## Replace the Power Steering Pump Fuse

An updated fuse has been implemented to improve the power steering system performance during extended full lock operation.

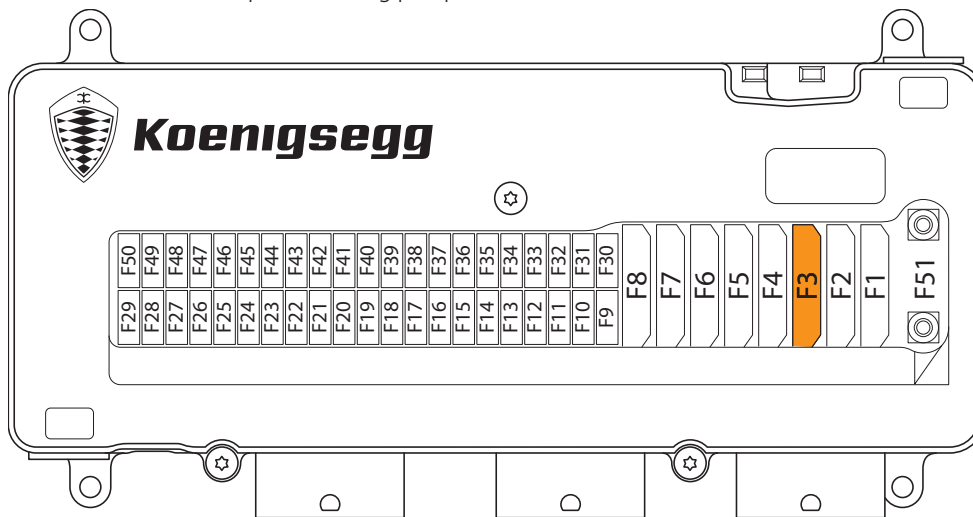
Install the new fuse for the power steering pump and attach a new fuse list label.

1. Find the fuse F3 for the power steering pump.

2. Remove and discard the fuse F3.
3. Install the new fuse to the F3 position.

Part: 3722-023
